Intel® Desktop Board DQ45CB Specification Update

May 2010

Order Number: E53961-006US

Specification Update for the Intel® Desktop Board DQ45CB

Figure 8. Detailed System Memory Address Map

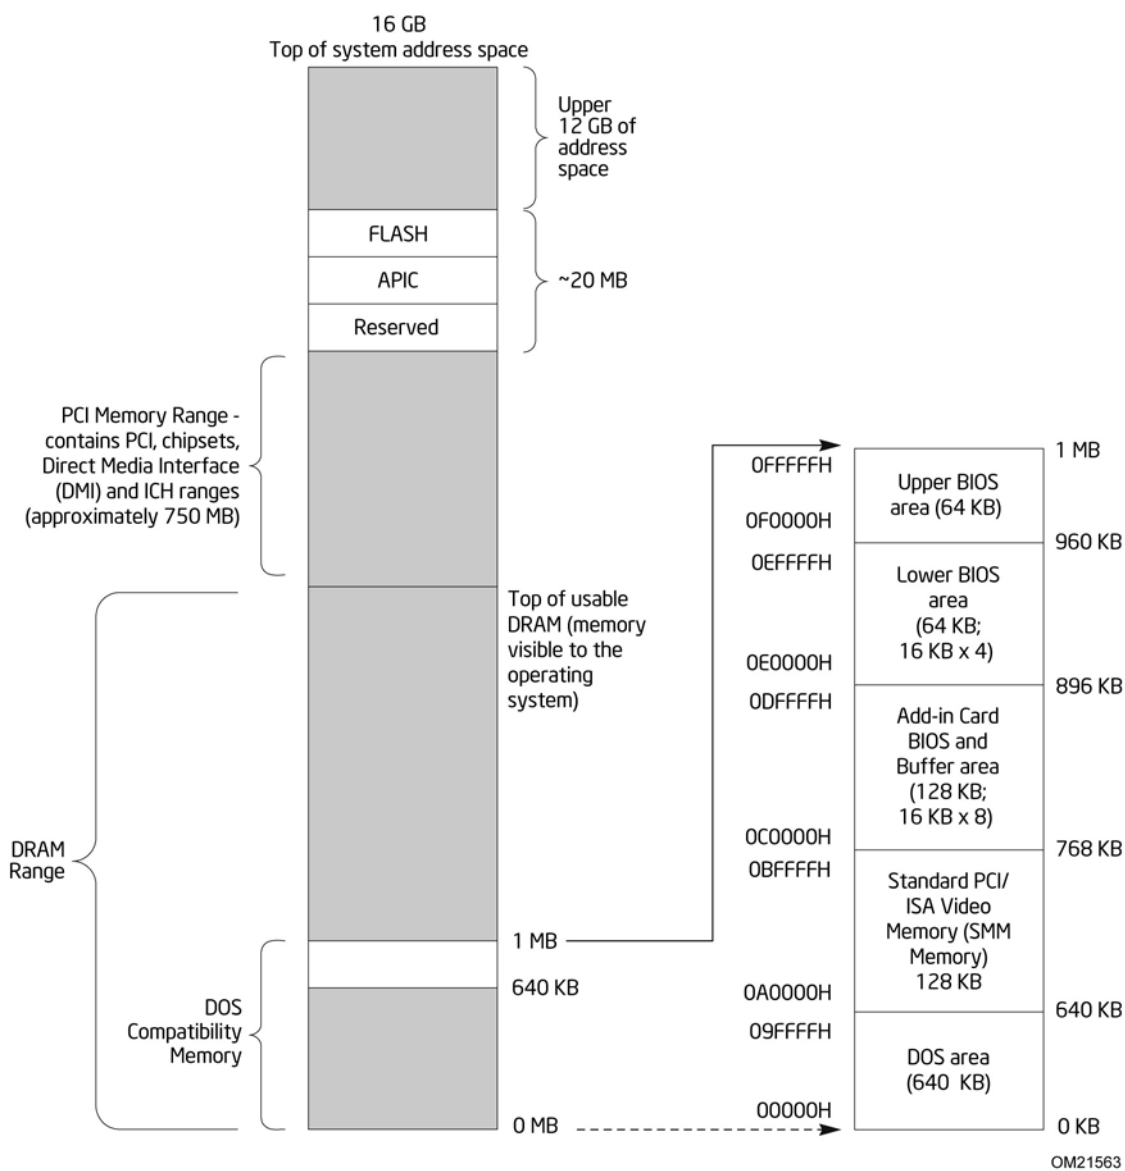
4. Support for up to 8 GB system memory has been changed to support for up to 16 GB system memory. Partial section of table 1 shown below.

The amount of installed memory that can be used will vary based on add-in cards, BIOS settings, and operating system installed. Figure 8 shows a schematic of the system memory map. All installed system memory can be used when there is no overlap of system addresses.

The board utilizes 16 GB of addressable system memory. Typically the address space that is allocated for PCI Conventional bus add-in cards, PCI Express configuration space, BIOS (SPI Flash), and chipset overhead resides above the top of DRAM (total system memory). On a system that has 16 GB of system memory installed, it is not possible to use all of the installed memory due to system address space being allocated for other system critical functions. These functions include the following:
